PLANNING COMMITTEE REPORT

PLANNING COMMITTEE		AGENDA ITEM NO:	B1
Date:	20 th February 2024	NON-EXEMPT

Application number	P2024/0027/NMA
Application type	Non-Material Amendment
Ward	Tufnell Park
Listed building	none
Conservation area	Within 50m of Tufnell Park Conservation Area Within 50m of Hillmarton Conservation area
Development Plan Context	Designated Brownfield Site Holloway Prison Site (HPS) SPD Emerging Site Allocation NH7 (November 2018). Local view corridor from Archway Road (LV4) Local view form Archway Bridge (LV5). Not in a location identified as suitable for tall buildings LL4 Local Landmark Camden Road New Church tower and Spire Within 100m of Strategic Road Network and Transport for London Road Network Major cycle route
Licensing Implications	None
Site Address	Former Holloway Prison, Parkhurst Road, London, N7 0NU
Proposal	Non-material amendments to planning permission ref: P2021/3273/FUL dated 05/08/2022. The amendments proposed include the installation of a second staircase into Block C1 and C2 for the purposes of fire safety with associated internal layout changes resulting in modifications to the dwelling mix, the number of wheelchair dwellings, floorspace for n

Figure 4: Block C1 staircase changes (proposed amended on right hand side)

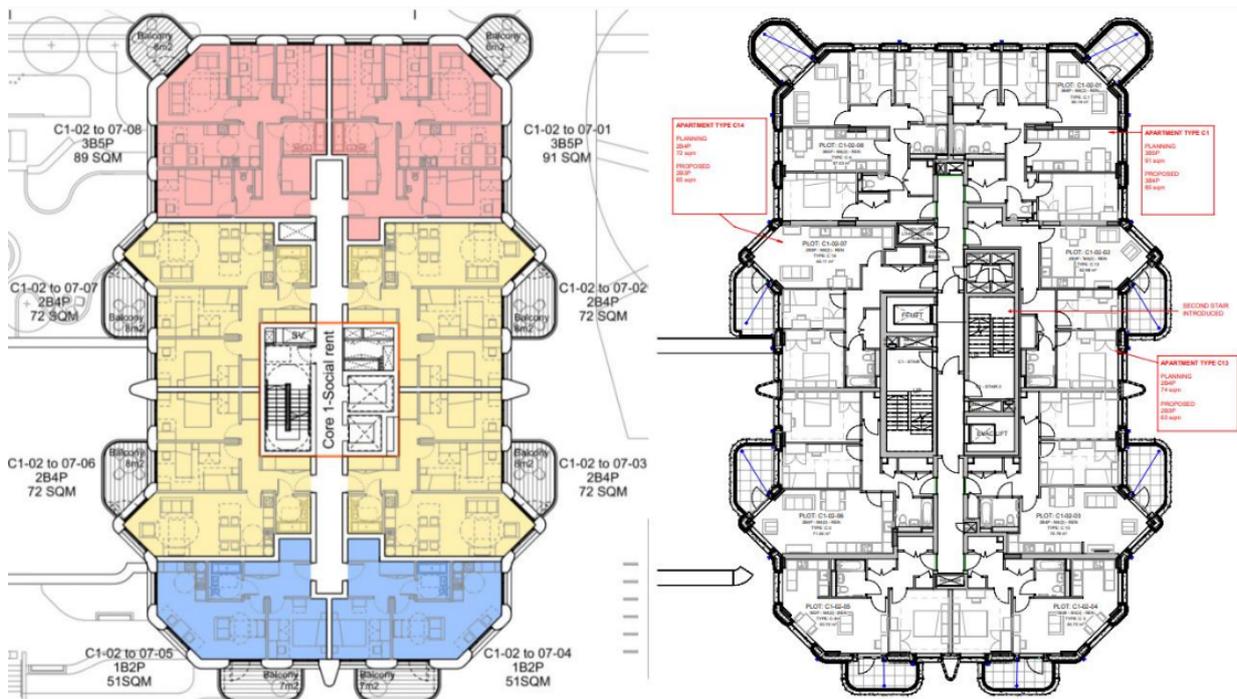
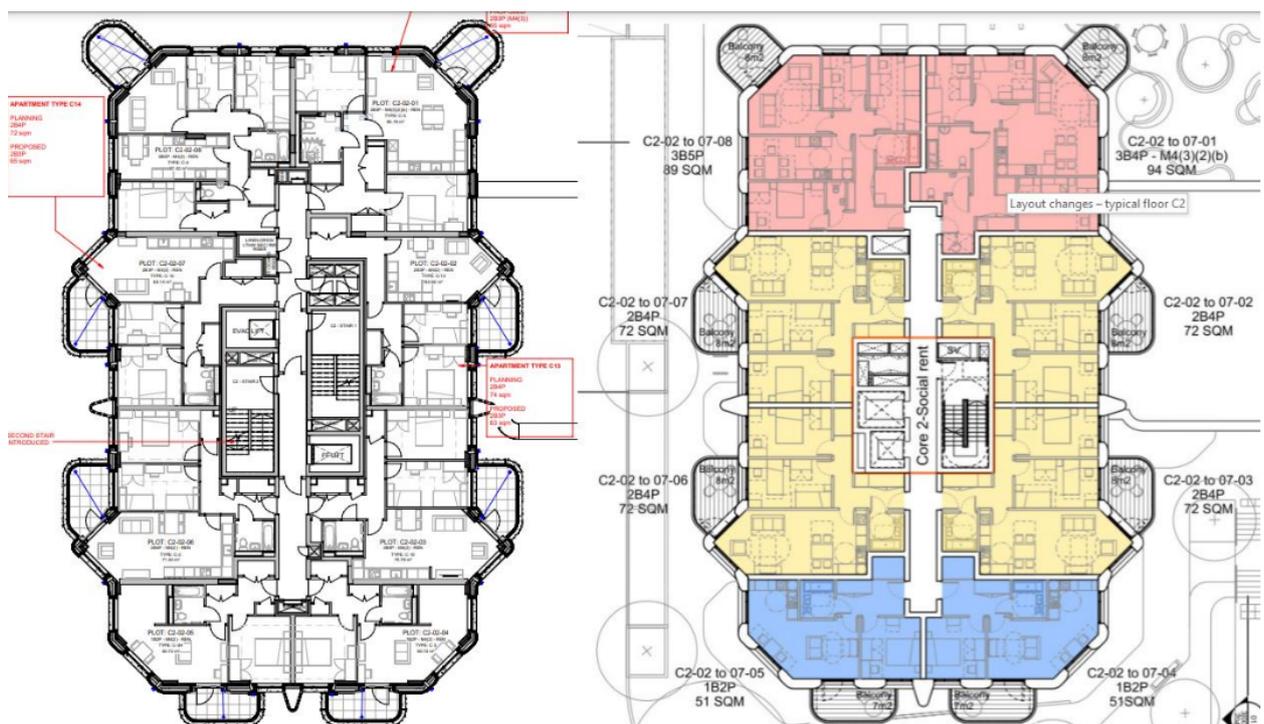
11.8 The introduction of a second staircase into blocks C1 and C2 result in a reduction of around 35 – 40sq.m of functional residential floorspace per floor which is now dedicated to circulation and access. There is no fundamental change to the layout. The originally designed staircase and lift core was located centrally around a central linear corridor in each block with a lift to one side of the corridor and a staircase to the other side. The change to the scheme results in the stair and lift core being elongated on each side of the central corridor to provide a staircase on both sides accessible from each floor with the exception of the basement in block C1.

Figure 7: Proposed upper ground floor to plot C

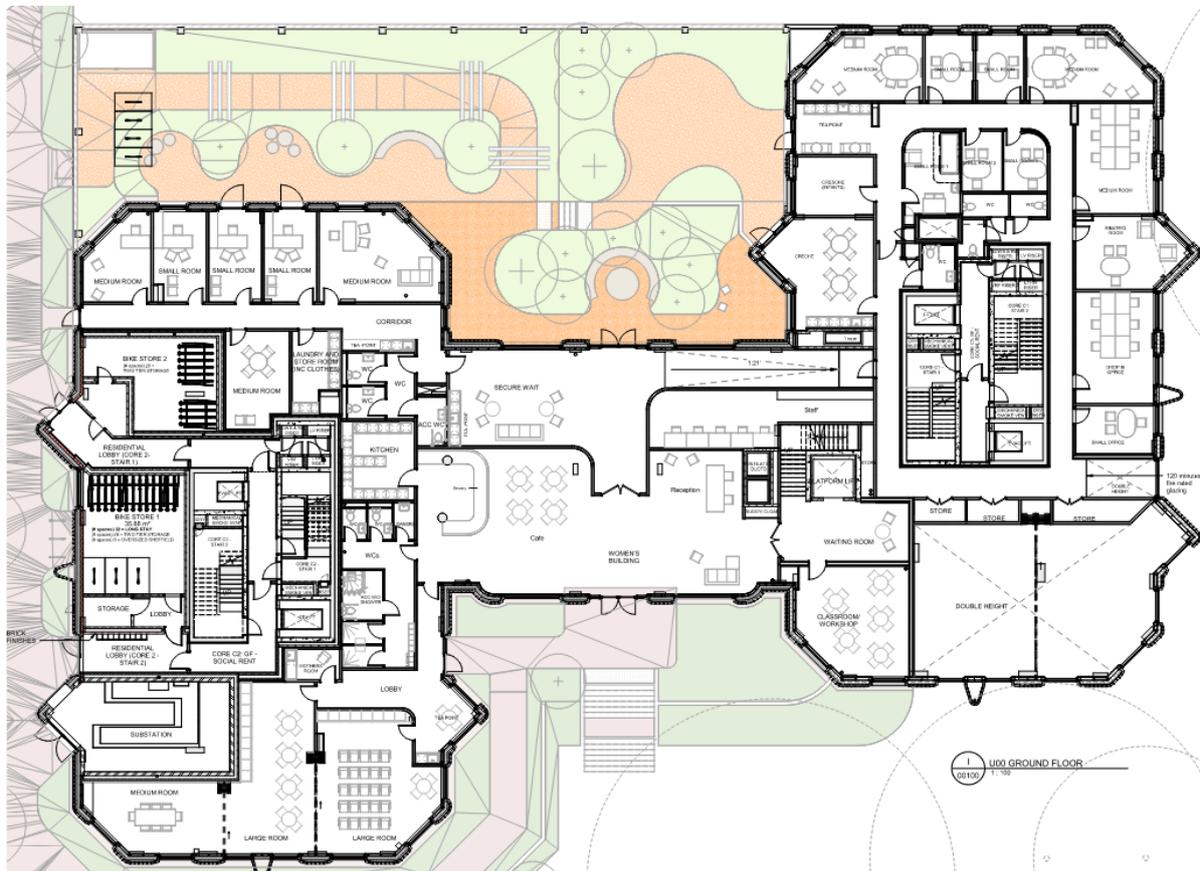
- 6.4 At lower and upper ground floor level, the proposed staircase amendments impact upon the layout and siting of building management facilities such as plant, utilities, cycle parking, toilets and showers and generally involves the re-siting of partitions rather than the removal of such facilities. With respect to the Women's Building, the proposed amendment maintains a double floor height dividable multipurpose hall along with meeting rooms, toilets and refuse storage. The larger staircase core absorbs some of the space and therefore at the lower ground floor, the dedicated Women's building floorspace now

encompasses some of the area previously dedicated to general needs bike storage, however, the number of spaces indicated for the basement is proposed to increase despite a smaller storage area. A flexible commercial space at lower ground floor level is also proposed to decrease minimally. At the ground floor level, the number of cycle parking spaces is reduced from 122 to 52. However, the fundamental layout of the Women's Building remains the same with the same functions and divisions across the floor plan.
